| <i>Title</i> | <i>Changes to Hardware Watchdog</i> |
| <i>Author</i> | <i>R. Abbott, B. Abbott, Caltech</i> |
| <i>Date</i> | <i>7 August 2015</i> |

Overview

Figure 1 Front Panel of D1300642 showing PD and LED annunciations

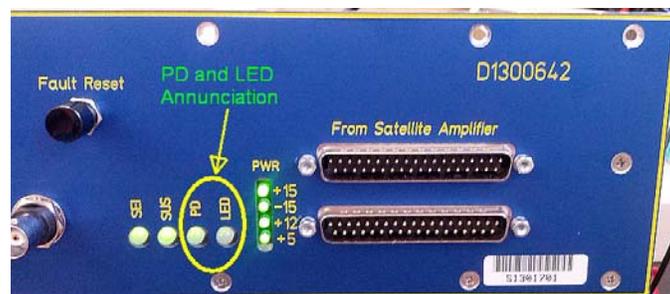
After powering up the HWWD chassis via the normal +/-18VDC feed on the rear panel, the signature observation indicating a successful code update is that the front panel LEDs annunciating the “LED” and “PD” states will initially simultaneously flash to indicate the loaded code revision.

For example, for code revision-2, both LEDs will simultaneously flash two times before beginning the normal operation of the HWWD function. This process is invoked each time the HWWD chassis is powered up.

Figure 3 Logic Board Overview

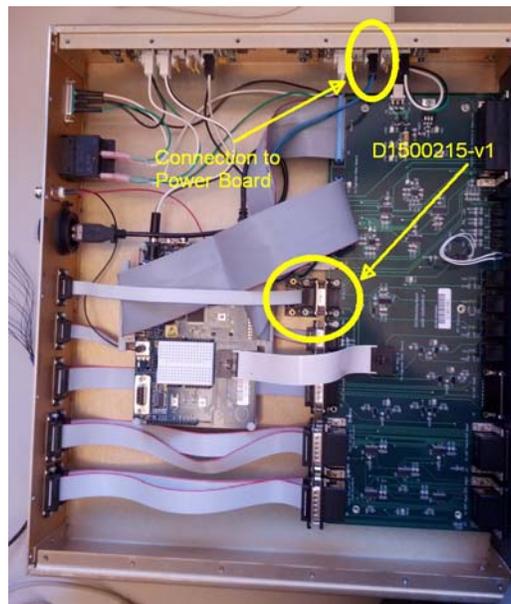
The D1500215-v1 Logic Inverter Board is shown installed into the HWWD chassis below. Note the use of pan head 4-40 screws to ensure a solid physical connection for the small Logic Inverter. Also of note is the Logic Inverter power connection that derives +15VDC from a spare connector on the internal +/-15VDC power board.
